REMARKS

Application No. 09/940,689  
Reply to Office Action dated December 17, 2003

*Fig. 4*

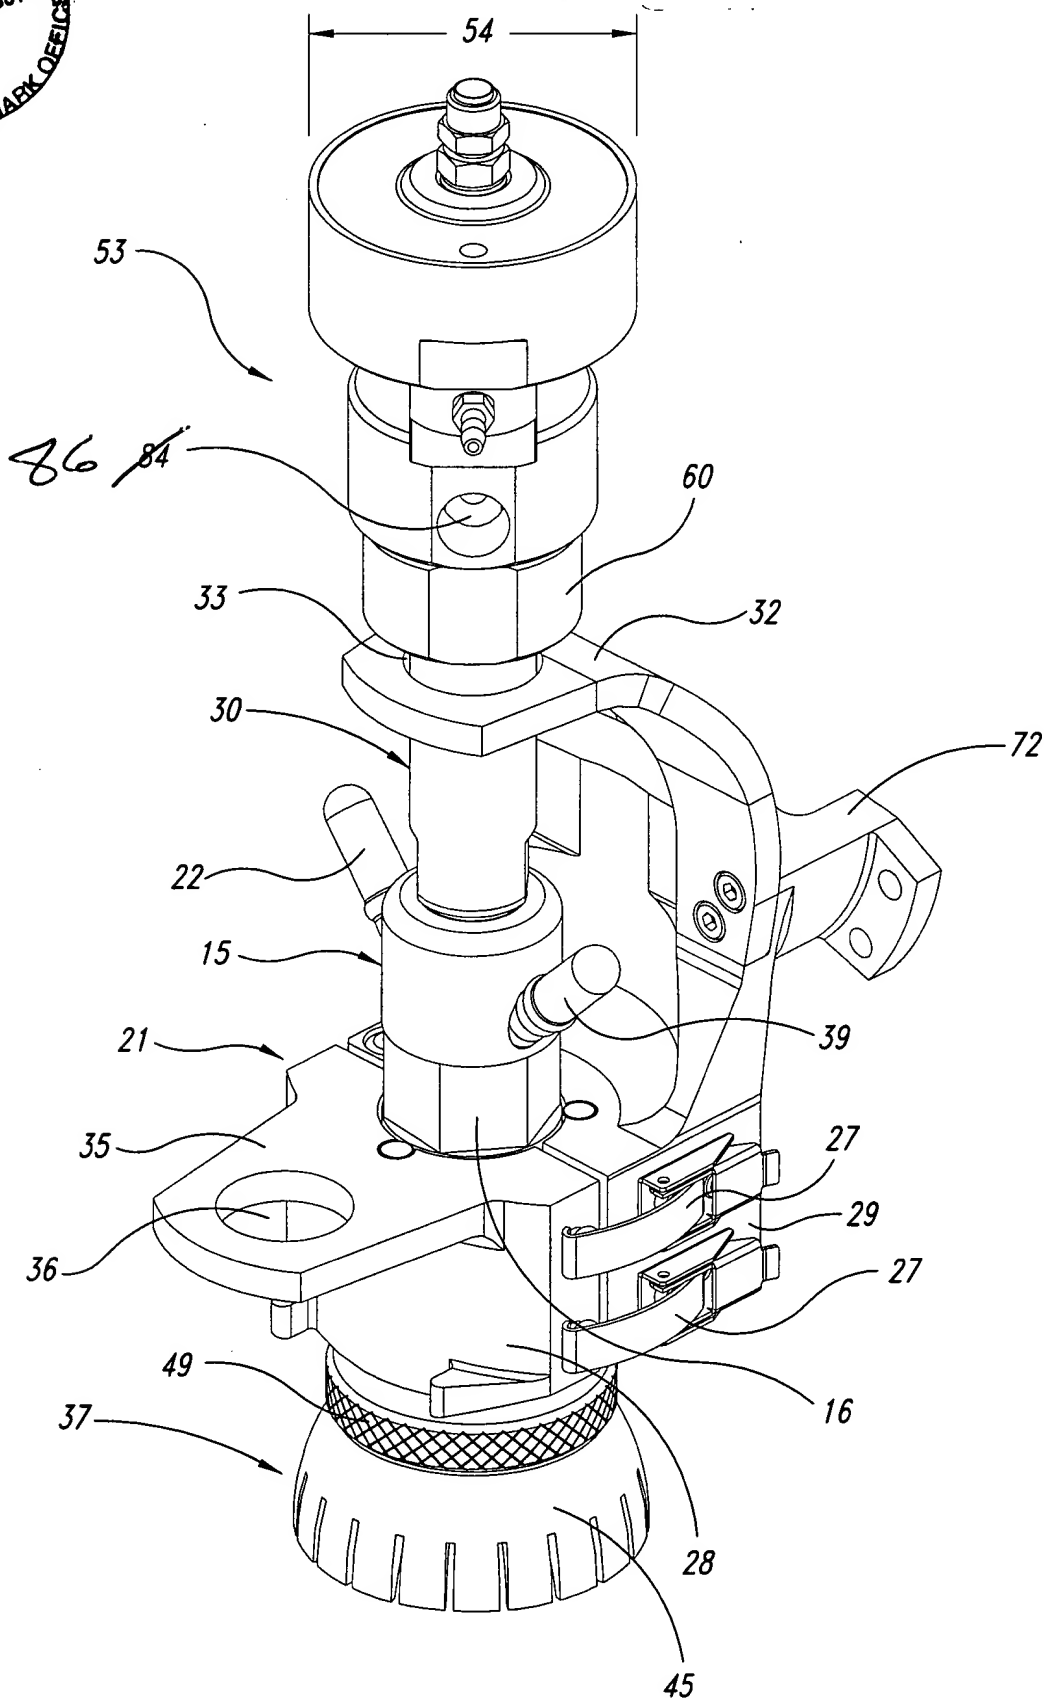
The drawings are objected to because reference number "84" was used for two different elements in the drawings. As shown in the proposed drawing corrections, Figure 4 has been amended to correct this error, as has the Specification on page 11, line 1.
